Re: FortisBC Energy Inc. (FEI)

**Application for a Certificate of Public Convenience and Necessity for the
Okanagan Capacity Upgrade Project (Application)**

**Response to the Residential Consumer Intervener Group (RCIG) Information
Request (IR) No. 1**

95022.383 - 98994.444

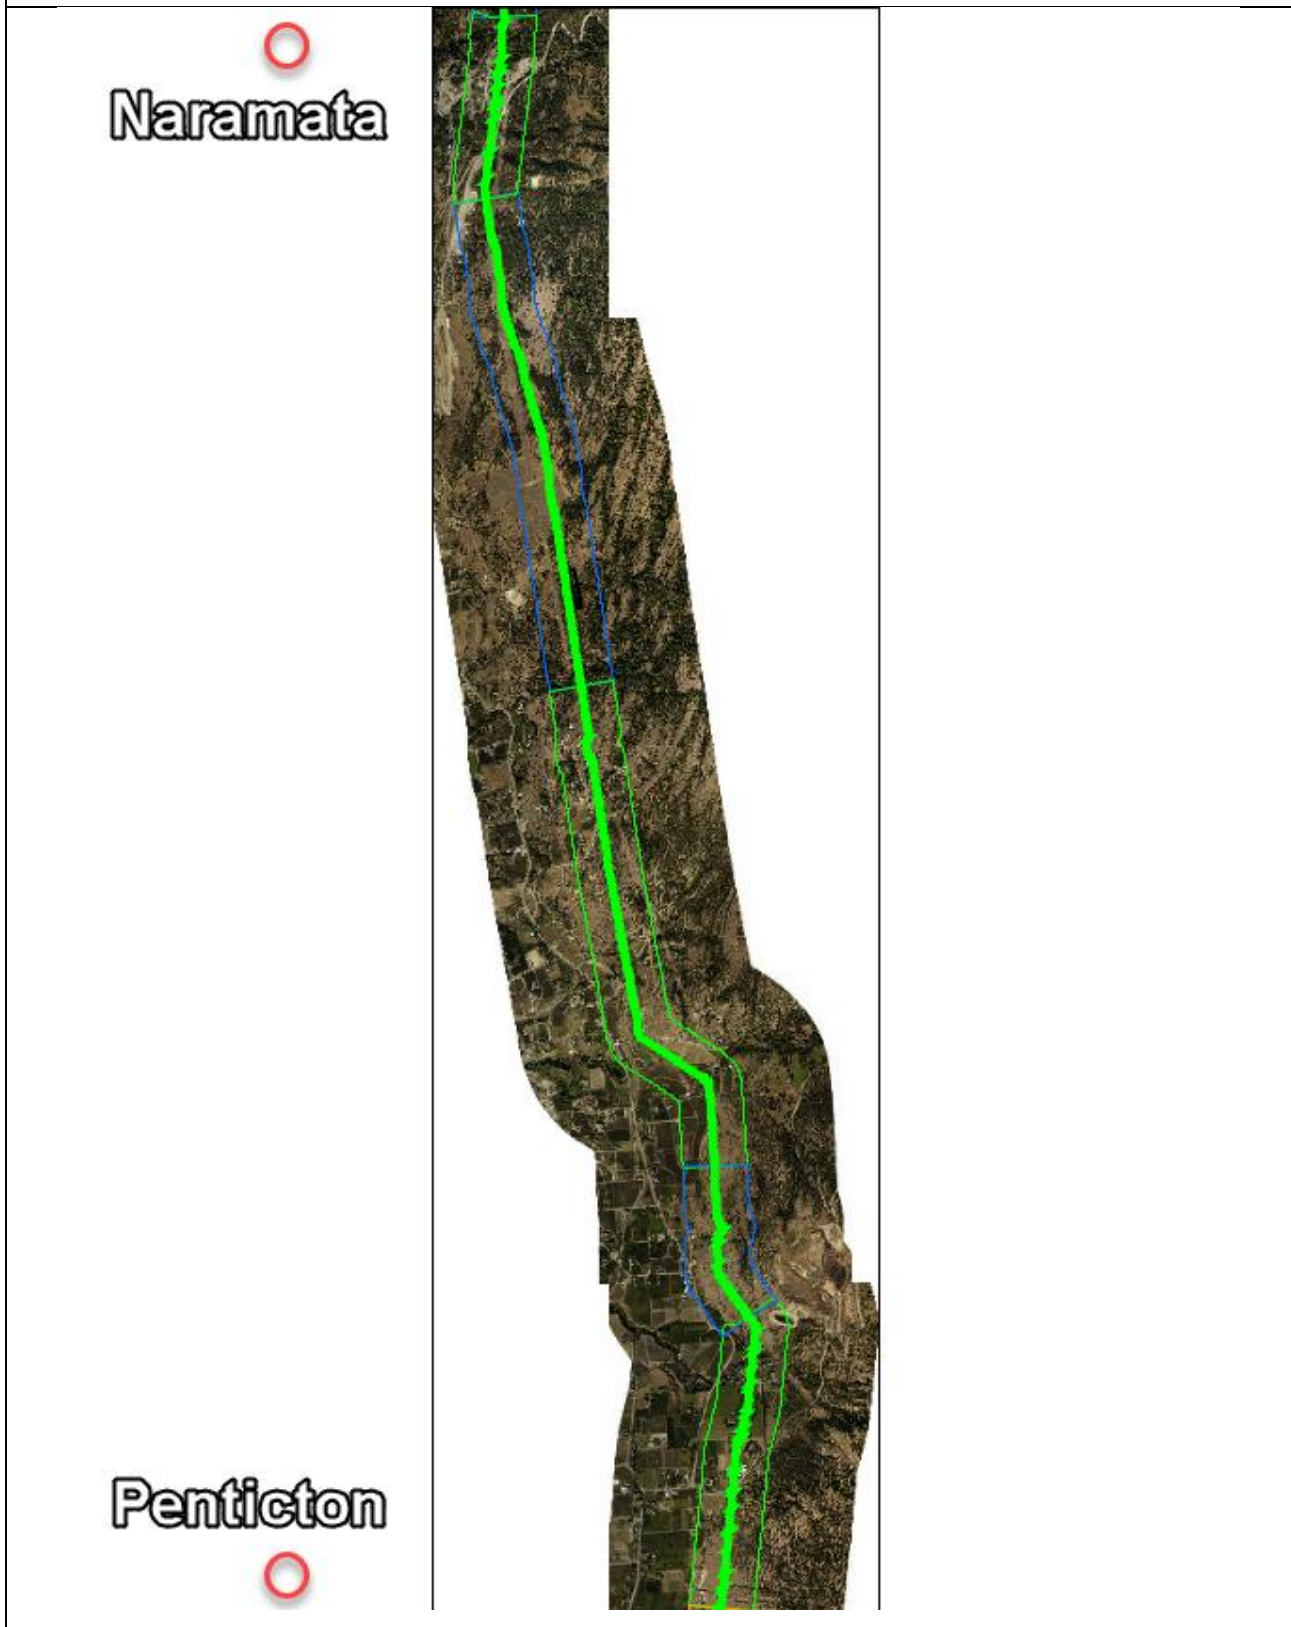
8.1 Provide a map of the VER PEN 323 line that shows the class locations along its length.

Class location changes cannot be shown clearly on a single map. Please refer to Attachment 8.1 for screen captures which show the full length of the VER PEN 323 pipeline in sections, with Class 1 locations outlined in blue, Class 2 locations outlined in green, and Class 3 locations outlined in dark yellow. Start and end points correspond to metres along the pipeline, starting from the north end of the VER PEN 323 and terminating at the south end of the VER PEN 323, a length of 98,994.444 m or 98.99 km. This information is also provided in the table below.
